Access Compliance Report Public Rights-of-Way (Pedestrian Signals)

Main Street: MCFADDEN_AVE Cross Street: BEACH_BLVD Location: NW

ADA ID: SGRK211005144447 Signal Type: One Push Button-APS Overall Compliance: No Severity Scores: BTN 1: 25 BTN 2: N/A No BTN: N/A

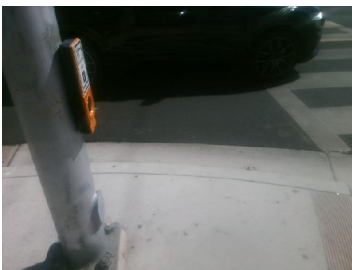
OC Std/PROW: MUTCD 4e.08, R404.2

Possible Solutions: Replace Signal Push Button With APS Button. Remove & Relocate Sign.
